Access Compliance Report Public Rights-of-Way (Curb Ramps)

Main Street: HUNTSMAN_RD Cross Street: SKYLINE_DR Location: SE

ADA ID: RPRK211013181032 Ramp Type: Type 4 - Parallel Initial Pass/Fail: Fail Overall Compliance: No Severity Score: 2

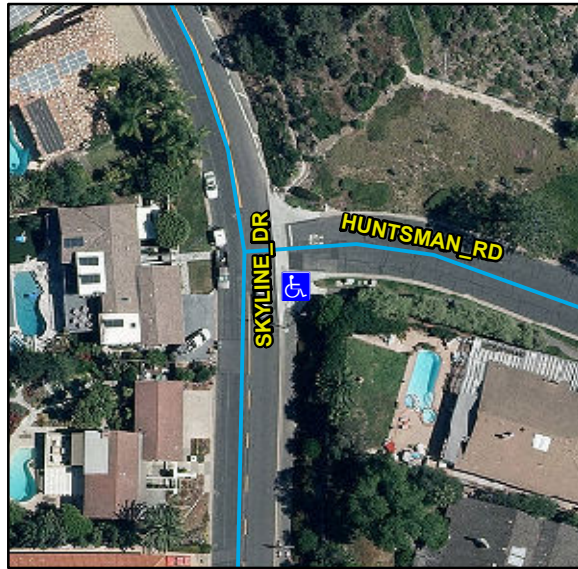
Compliance	Description	Data	Compliance	Description	Data
N/A	Ramp Length LT (in)	184	N/A	Ramp Length RT (in)	96
Yes	Ramp Width LT (in)	86	Yes	Ramp Width RT (in)	84
Yes	Ramp Run Slope LT (%)	5.3	Yes	Ramp Run Slope RT (%)	1.6
Yes	Ramp Cross Slope LT (%)	1.6	No	Ramp Cross Slope RT (%)	2.3
N/A	Landing Present	N/A	N/A	DWS Provided	N/A
N/A	Landing Length (in)	N/A	N/A	DWS Contrast	N/A
N/A	Landing Width (in)	N/A	N/A	DWS Length (in)	N/A
N/A	Landing Run Slope (%)	N/A	N/A	DWS Full Width	N/A
N/A	Landing Cross Slope (%)	N/A		DWS Offset Type	N/A
N/A	Landing Movement Obstructed?	N/A	N/A	DWS Offset Left (in)	N/A
	Landing Movement Type	N/A	N/A	DWS Offset Right (in)	N/A
N/A	Landing Shared	N/A			
N/A	Clear Space	Yes			
N/A	Clear Space To Crosswalk (in)	N/A			
N/A	Marked Crosswalk 1	No	N/A	Marked Crosswalk 2	No
	Crossing 1 Direction	N		Crossing 2 Direction	W
	Marked Crosswalk 1 Width (in)	N/A		Marked Crosswalk 2 Width (in)	N/A

Remove & Replace Curb Ramp With Two New Directional Ramps or Equivalent.

R304.5.3, STD 1115
